BIG ROCK POINT NUCLEAR PLANT

AMENDMENT TO FACILITY OPERATING LICENSE

Amendment No. 46  
License No. DPR-6

ATTACHMENT TO LICENSE AMENDMENT NO. 46

Figure 6.2-1

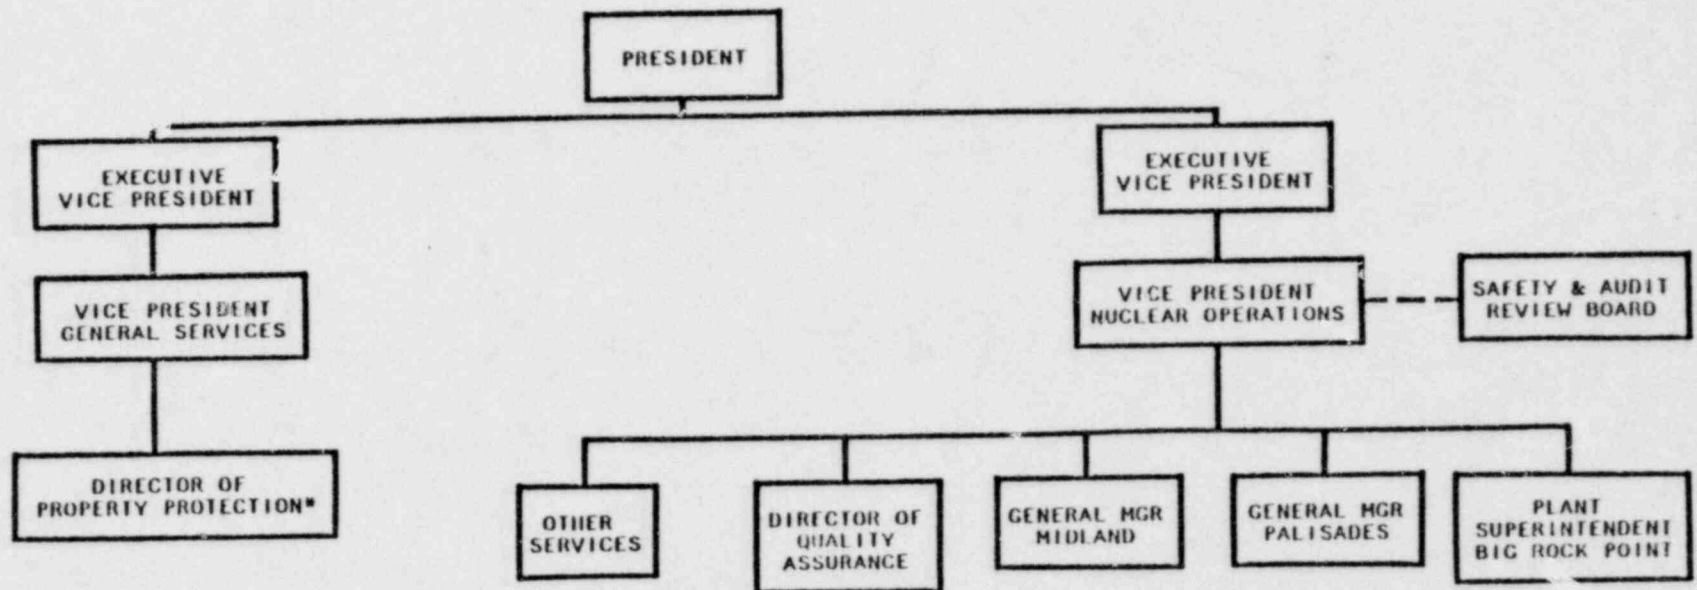
10-2 (Figure 6.2-1)

The off-site organization for plant management and technical support shall be as shown on Figure 6.2-1.

Figure 6.2-2

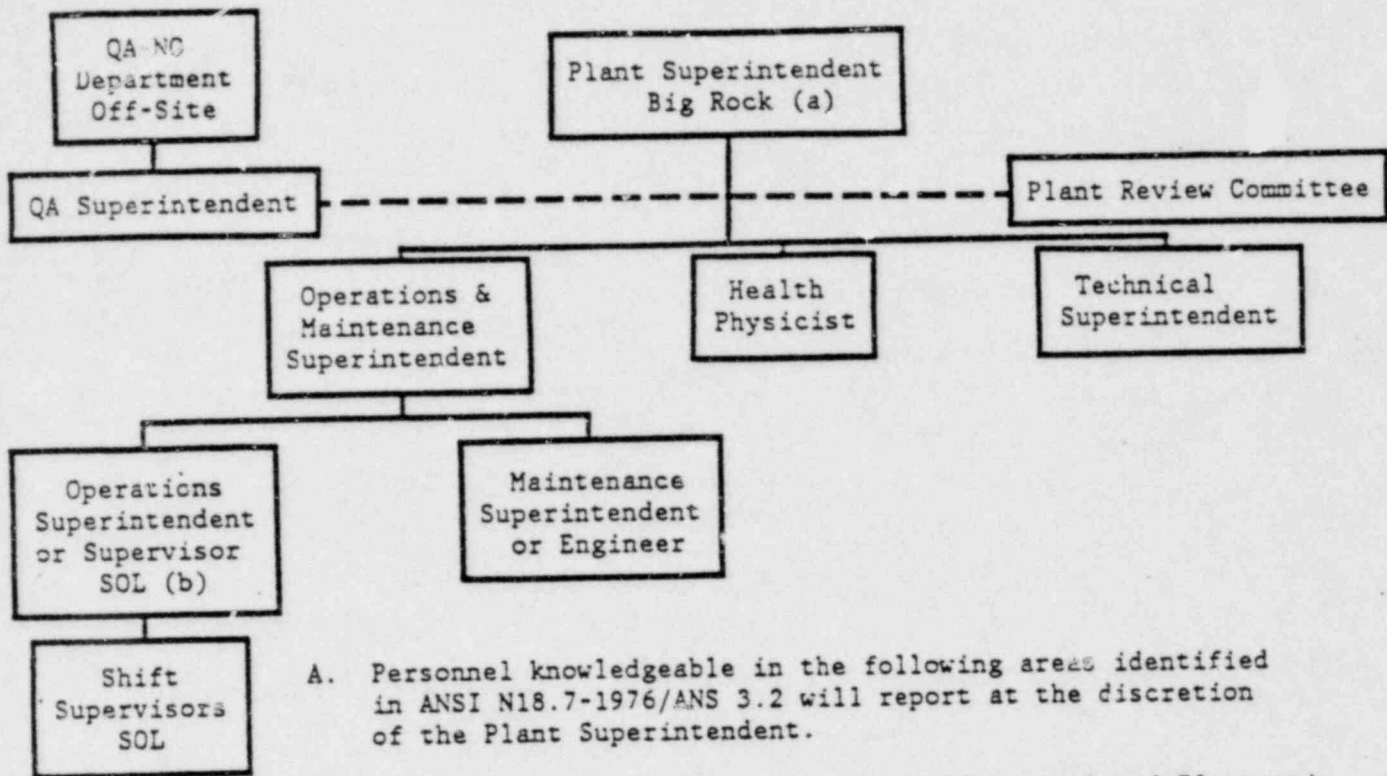
10-3 (Figure 6.2-2)

The plant organization shall be as shown on Figure 6.2-2, and:

(a) Responsible for the Plant Fire Protection Program implementation.

(b) Either the Operations Superintendent or the Operations Supervisor will hold an SOL and meet the other requirements of 6.3.1 of these Technical Specifications (as applicable to Operations Manager in ANSI N18.1). The individual holding an SOL shall be responsible for directing the activities of licensed operators.
